Our Ref: JBR/THE0583-047/The Baxter Group Limited
Your Ref: LCC/2023/0030

Final Response to Lancashire County Council Highways Letter dated 14 February 2025 regarding Land off Bourbles Lane, Preesall.

Proposed The extraction and processing of sand and gravel including the construction of new site access roads, landscaping and screening bunds, minerals washing plant and other associated infrastructure with restoration to leisure end-uses, agricultural land and biodiversity enhancement, using imported inert fill.

Location Land off Bourbles Lane, Preesall

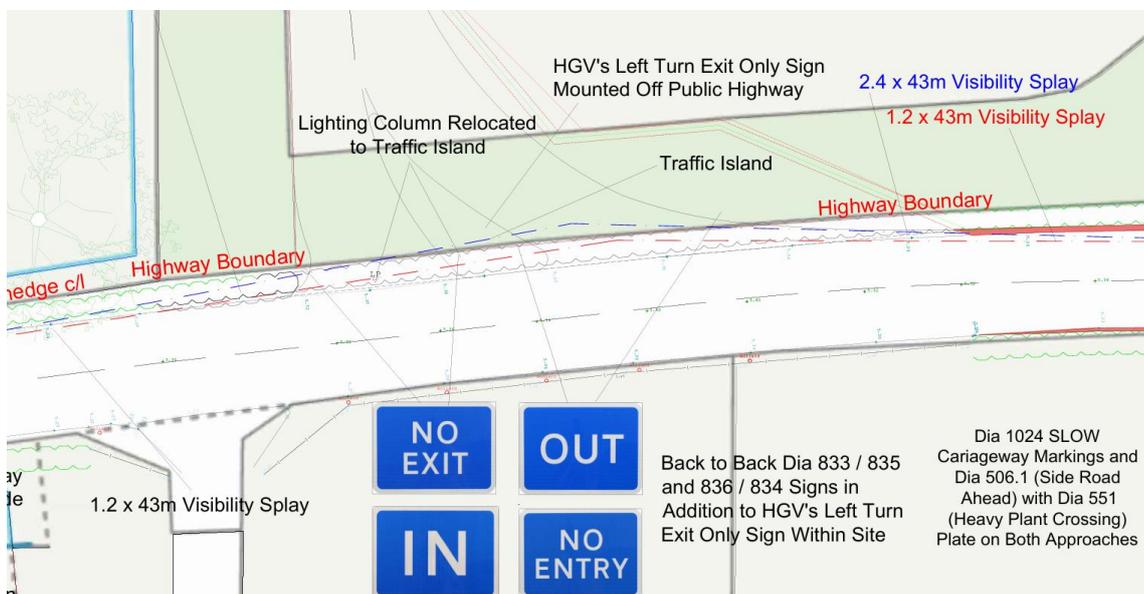
It is now apparently considered by officers that the splay should in fact be 2.4m x 58m. This has only been communicated to the Applicant recently notwithstanding the extensive discussions that had previously taken place. Had the Highway Authority considered that the previously agreed 1.2m was no longer appropriate, or that there should be no attempt to control driving to the speed limit, this could have been communicated to the Applicant at any time and most certainly well before a third meeting which took place in December 2024. The purpose of the December 2024 meeting was intended to be where all outstanding matters were to be presented so that a final submission could be made. The visibility splay volte face was not mentioned.

The upshot of the latest position of the Highway Authority is the splay should be designed to accommodate the illegal driving that was taking place on Lancaster Road. It also reversed the previous agreement concerning the 1.2m set-back. The issue is addressed more fully below.

The current LCC Highways consultation response incorrectly states that the access can only provide a 1.2 x 43m splay. This is factually incorrect. The drawings simply show what had been agreed can be achieved. The 2.4m set back is stated to be necessary to allow the access to be used by light vehicles. As indicated previously this must have been known when the 1.2m set back was “*happily accepted*” as above.

Secondly, the extract from the site access drawings below shows that a 2.4m splay can readily be provided. This has been drawn at the required 43m for traffic travelling at 30 mph. A considerably longer splay could be accommodated over the hedge, far in excess of the 58m now considered necessary (and in such a case the speed activated warning sign would not therefore be necessary and would not need to be provided).

As can be seen above, the splay would be well within the highway boundary or the land that has been acquired for the new access.

Finally, on this point it is unclear how LCC Highways has come to assess the available distance referred to by them. Nothing has been presented to demonstrate their assessment. The above extract is, however, based on the accurate topographic survey that has been undertaken for the development and the definitive highway records. And shows that significantly more than a 2.4 x 43m splay could be achieved.

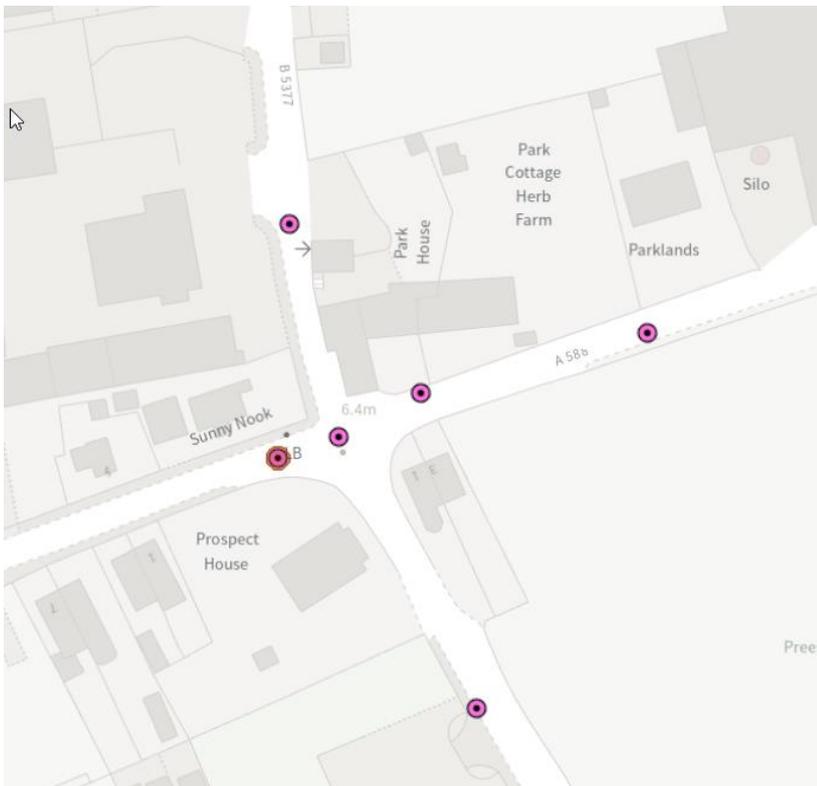
The applicant was requested to investigate this junction, despite there being no accidents identified in the search undertaken for the original Transport Assessment. At the second September 2024 meeting, the suggestion was that signs indicating HGV's may approach in the centre of the road be provided as part of the development. These were then proposed as part of the development from thereon. The question of whether the signs could be provided in the highway was initially raised at the December 2024 meeting. The January 2025 Supplementary Information shows where the signs could be provided within the highway.

Ironically, had such signs been erected by the Highway Authority the 2015 accident may not have happened.

Figure 6.18 from MfS, reproduced below, shows typical vehicle widths.

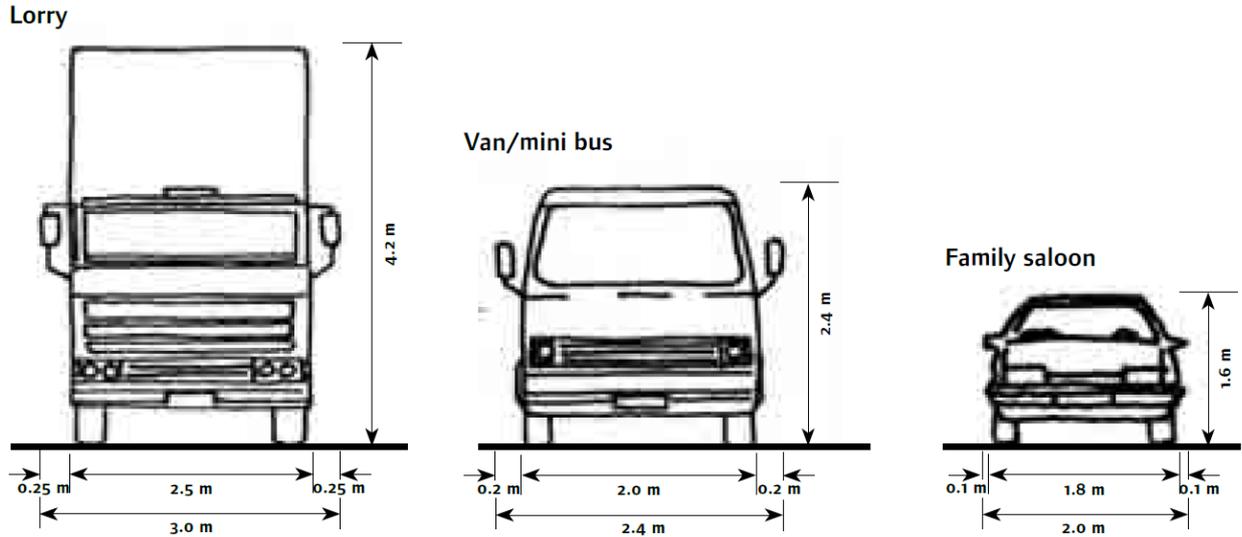
A carriageway of 5.5m can accommodate two-way HGV movements, however, this is on a straight and has minimal clearance between vehicles. Where bends exist greater widths of carriageway would be required. Further, the above does not factor in the needs of pedestrians as it assumes footways adjacent to the carriageway would be available.

Figure 7.1 from MfS, reproduced below, shows what carriageway width can typically accommodate.

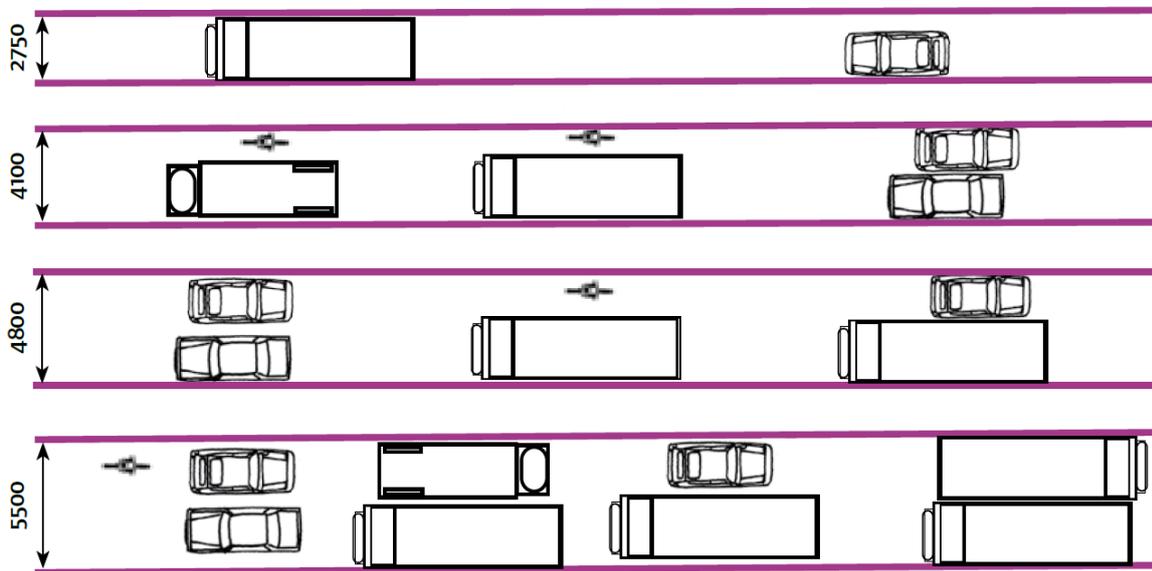
On Lancaster Road in the vicinity of the site there are no footways and very narrow verges with hedges which leads to vehicles keeping away from the edge of carriageway, thus narrowing the effective carriageway width.
